SERVICE BULLETIN

Bulletin No.....: TS-U111

Bulletin Name.....: Filling Throat Of Fuel Tank

Vehicle Model.....: TS 45

Figure-4

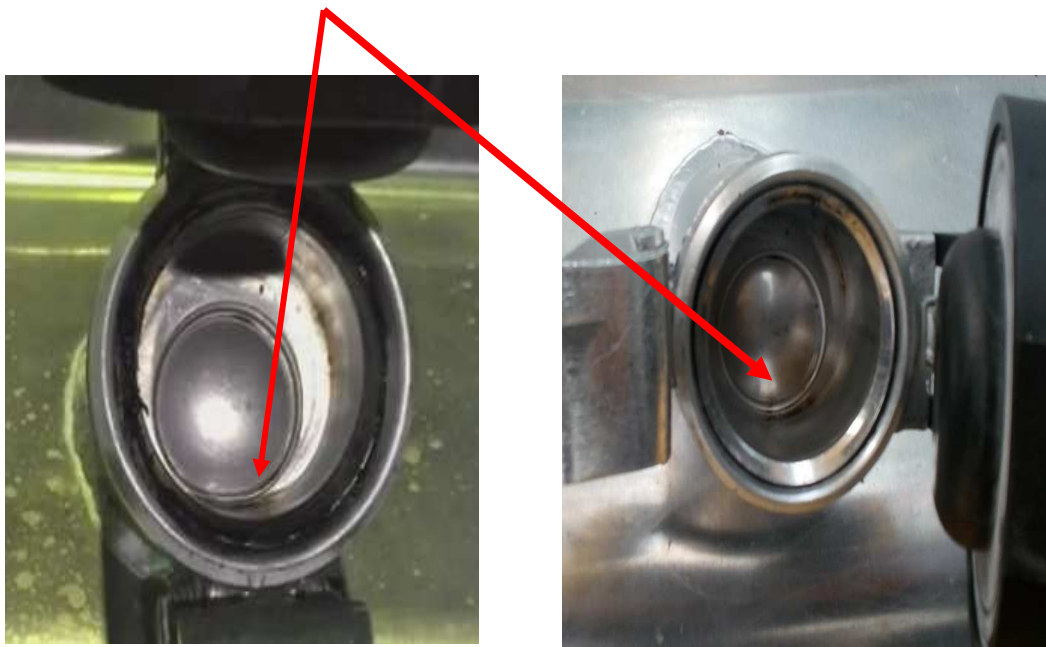
Step 4. . In both positions, flap must be adjusted so as to see the bottom of the tank as shown in figure 4.(see. **Figure-4**)

Figure-5

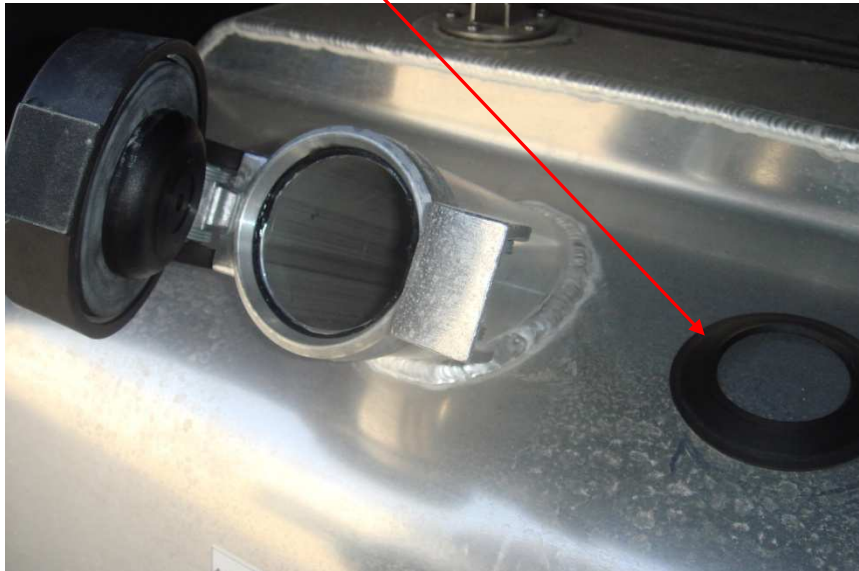
Step 5. Dismount the old gasket. (see. Figure-5)

Figure-6

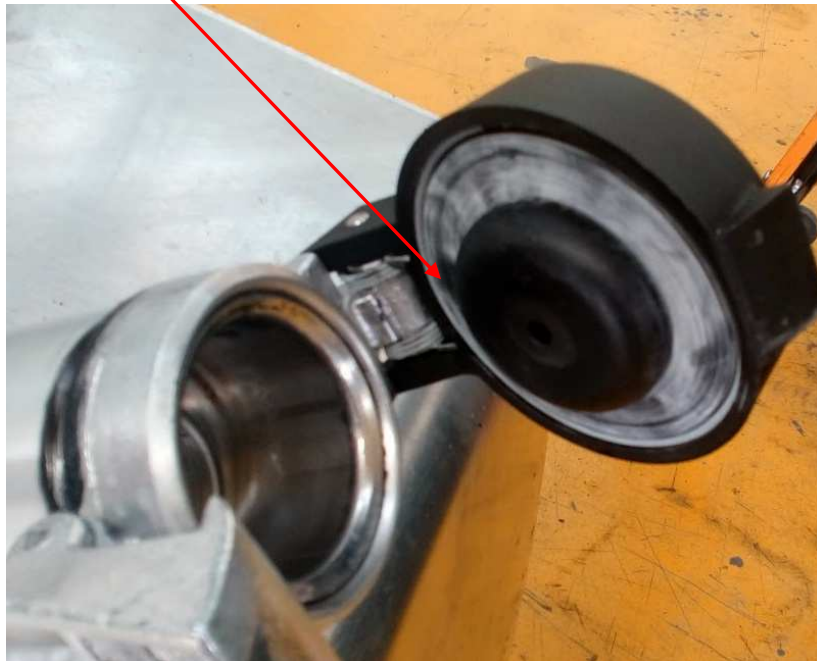
Step 6. Mount new gasket which located in RP160120 numbered kit as shown in Figure-6 (see. Figure-6)
